CHART STANDARDIZATION & PAPER CHART WORKING GROUP (CSPCWG)

CSPCWG Letter: 09/2012

Subject: Draft revision of S-4 Section B-300:

CONSOLIDATED RESPONSES TO CSPCWG LETTER 05/2011
DRAFT REVISION OF S-4 SECTION B-340 TO B-390 – ROUND 1

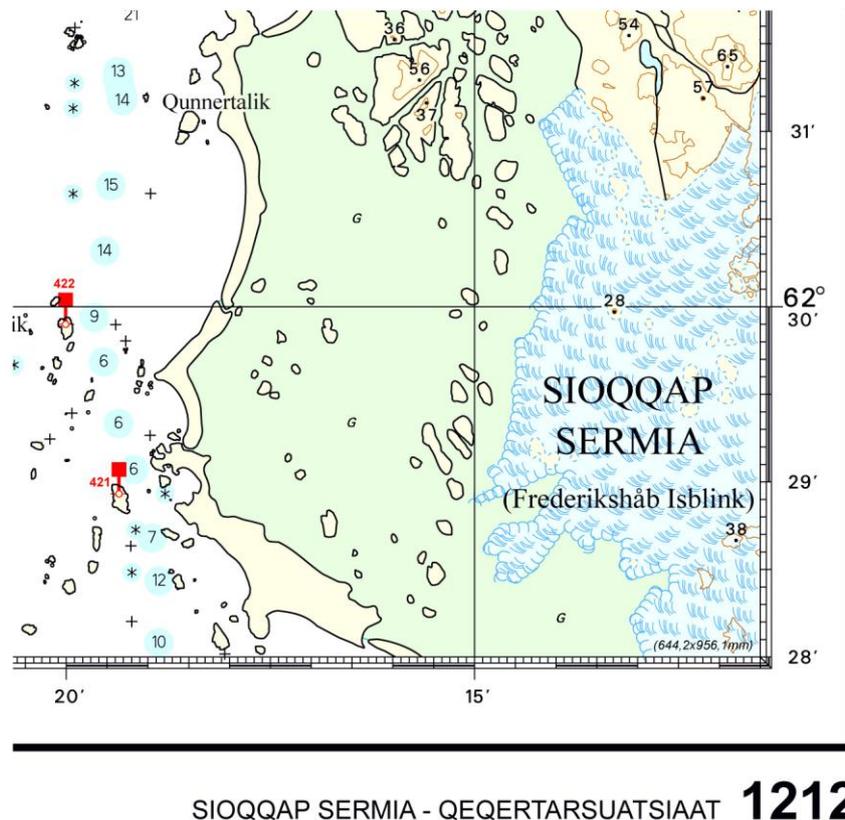
B-383: If D29 were to be used for both submerged and overhead cables [pipes], the only difference between the symbols would be the vertical clearance. If the vertical clearance is not known, how would this be distinguished as a submerged pipeline? Additionally, the difference in the symbols provides a clear distinction between features which may be an overhead hazard from features which may be a submerged hazard. Suggest retain current D28 symbol.

Chairman: accepted.

B-372.1

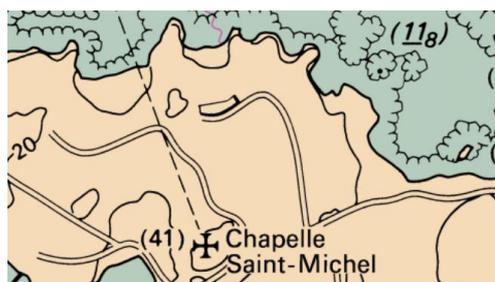
France agrees that generally it is useless to indicate where post offices are located. But in particularly isolated areas, it can be useful for the mariners to know where the post offices are, in order to define where to go. As the symbol already exists, it is easy to retain it.

B-375.1-2

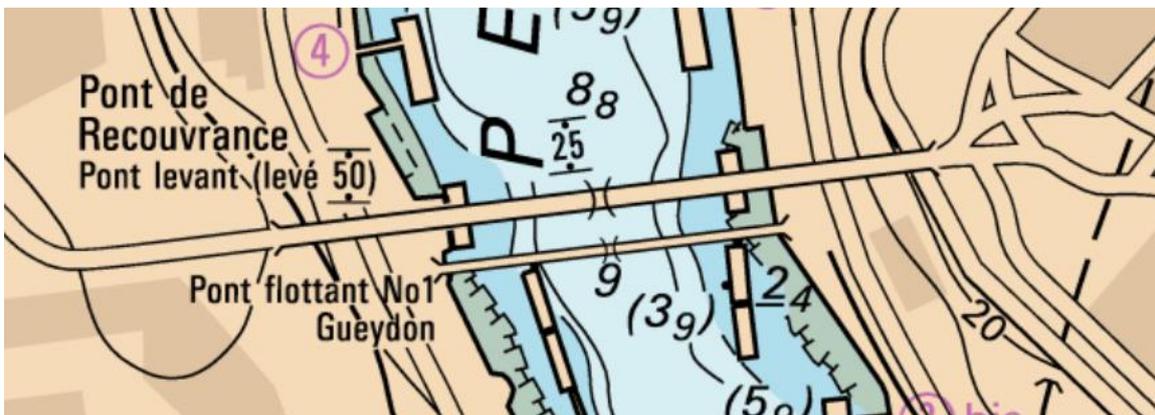
It is important to distinguish a tower which can be a "big" structure and a mast which can be a very light structure. The two kinds of symbol (E30.1 and E30.2) should be kept.

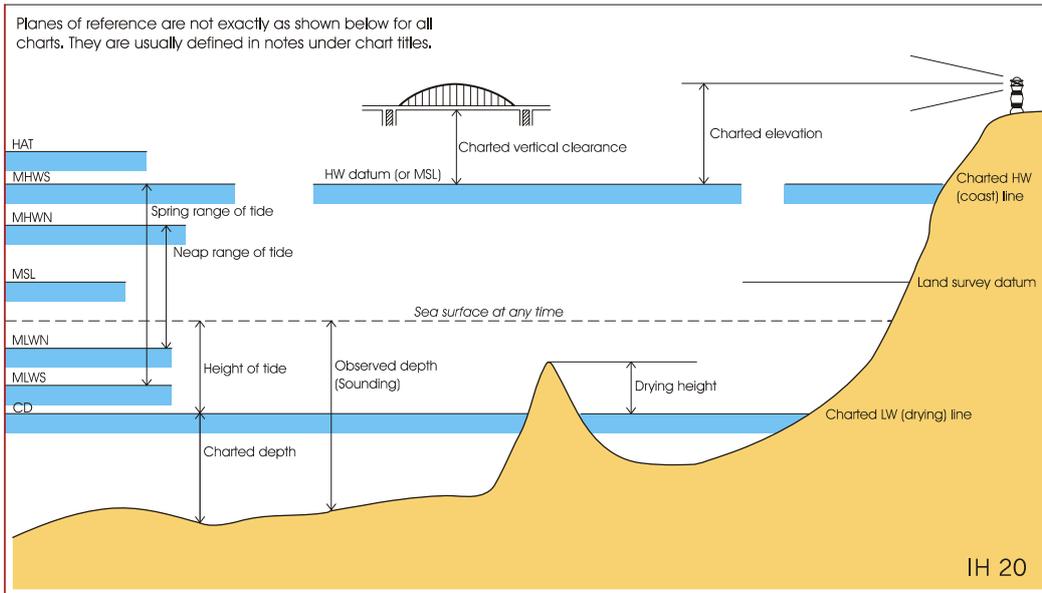
Comment: DID: replace by same graphic as B-302.2, updated as in latest printing of 5011. Also amend legend to left of bridge to 'Physical vertical clearance (black)' and change the legend to the right to magenta text: 'Safe vertical...'. Asked for a marked up copy if necessary. (Following discussions at
